Wildlife.ai WW500 Circuit Modification

Feb 25, 2025

Himax Technologies, Inc.
奇景光電股份有限公司

Load Switch C_T

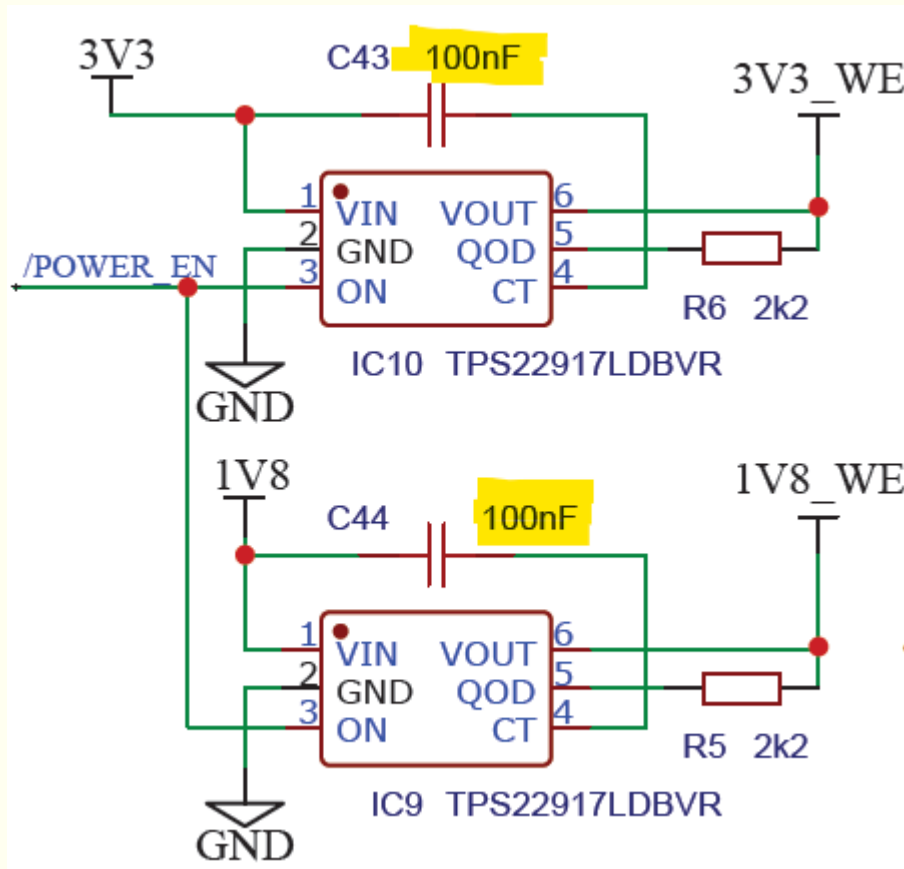
1. DPD mode issue (1V8_WE/3V3_WE)

a. 1V8_WE/3V3_WE switch capacitor : C43, C44 -> 1nF

- Adjustable turn ON limits inrush current (t_{ON}):
 - 5-V $t_{ON} = 100 \mu s$ at $72 \text{ mV}/\mu s$ ($C_T = \text{open}$)
 - 5-V $t_{ON} = 4000 \mu s$ at $2.3 \text{ mV}/\mu s$ ($C_T = 1000 \text{ pF}$)

CIS I2C Pull High

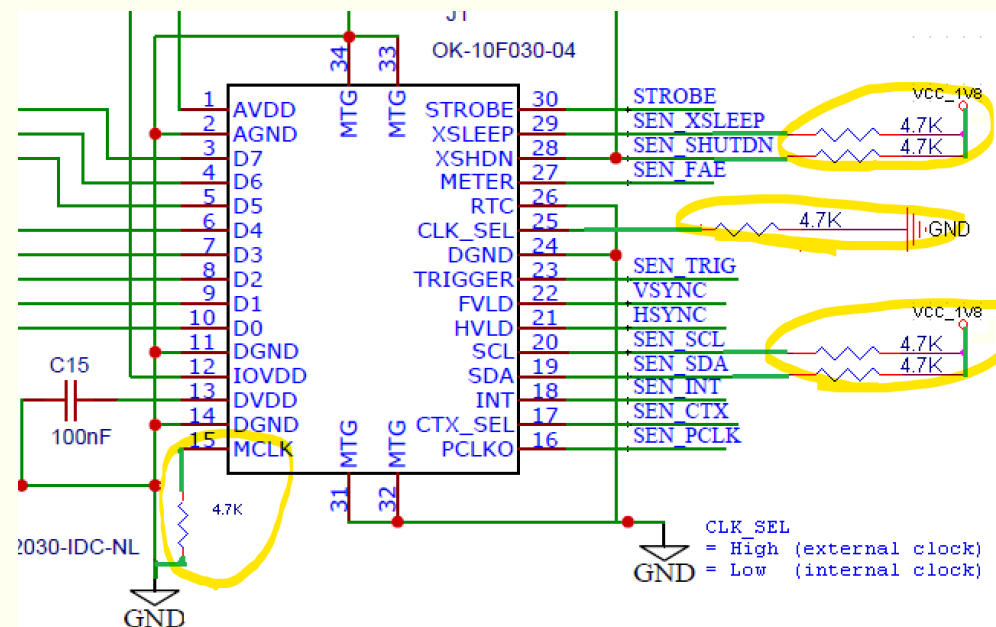
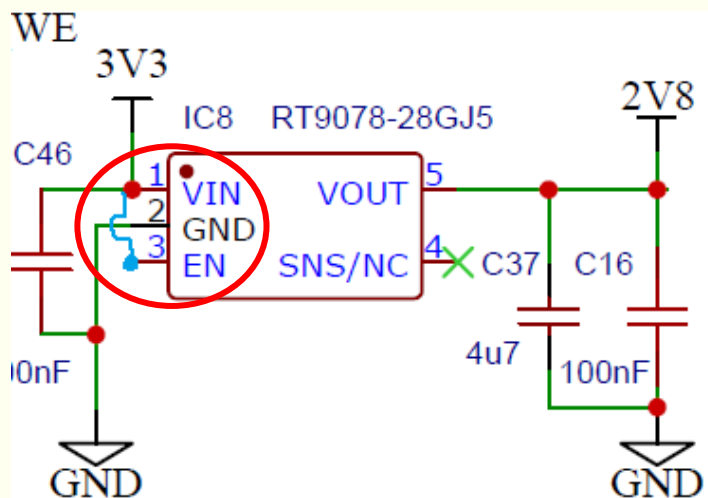
2. HM0360 I2C issue

- a. HM0360 SEN_SCL/SEN_SDA need to add pull-up resistors

HM0360 Always On Setting @WE2

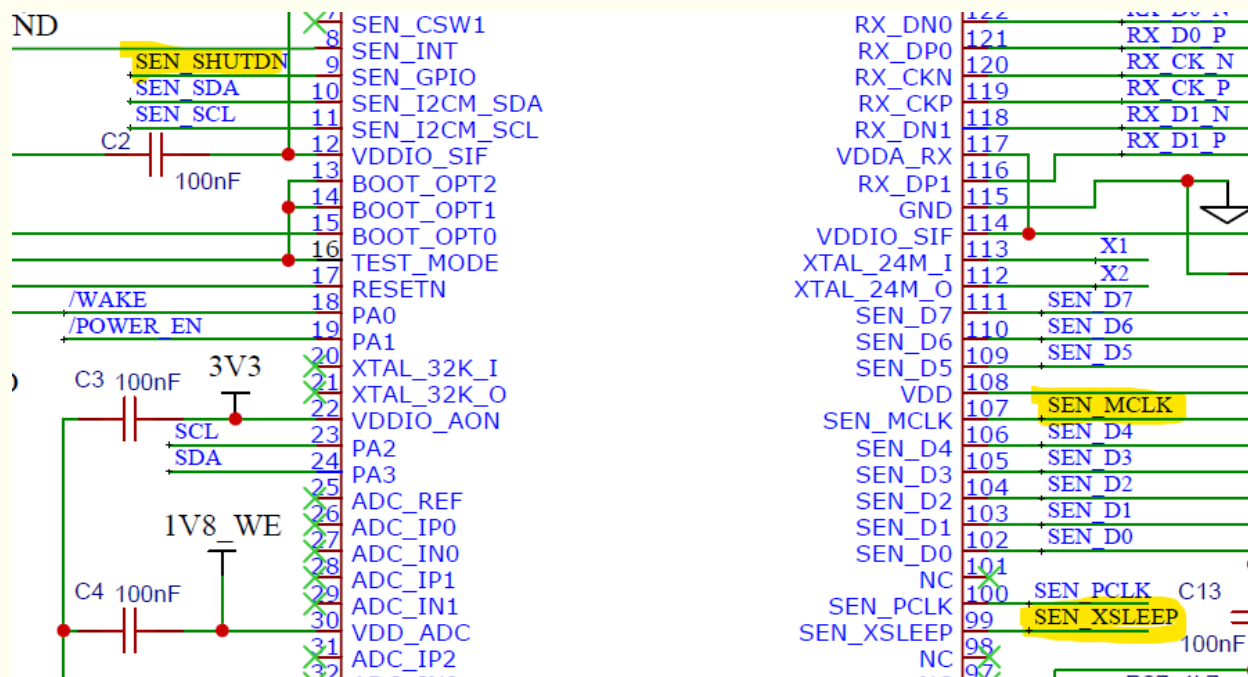
3. HM0360 should be always on
 - a. HM0360 2V8 always on
 - b. HM0360 XSLEEP/XSHDN should be pull-high (always on)
 - c. WE2 SEN_XSLEEP/SEN_GPIO should be NC
4. HM0360 should be set the oscillator mode
 - a. HM0360 CLK_SEL/MCLK connect to DGND (OSC mode)
 - b. WE2 SEN_MCLK should be NC

SEN_INT Signal State

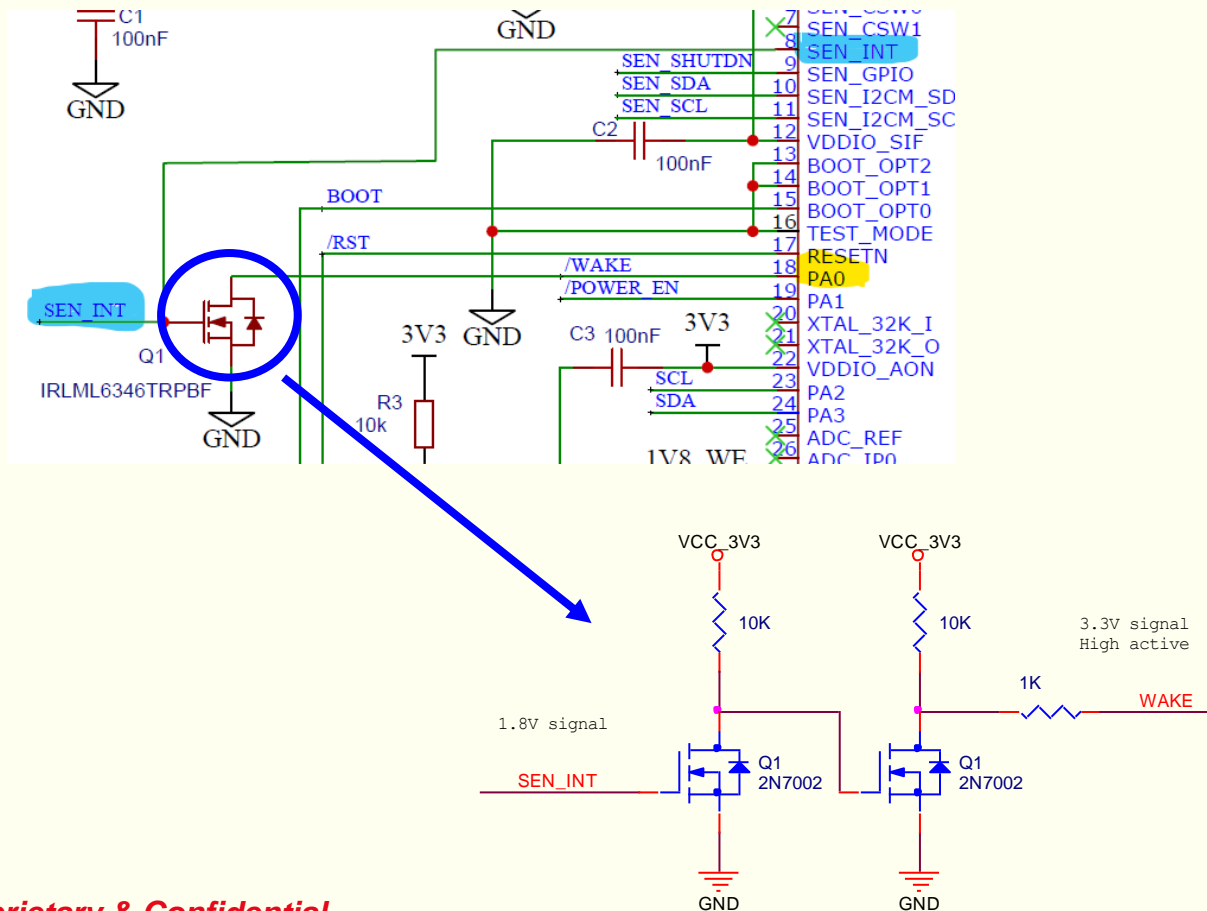
5. HM0360 interrupt to WE2 issue

a. Add level shift circuit (1.8V to 3.3V) between HM0360 INT(1.8V) and WE2 PA0(3.3V)
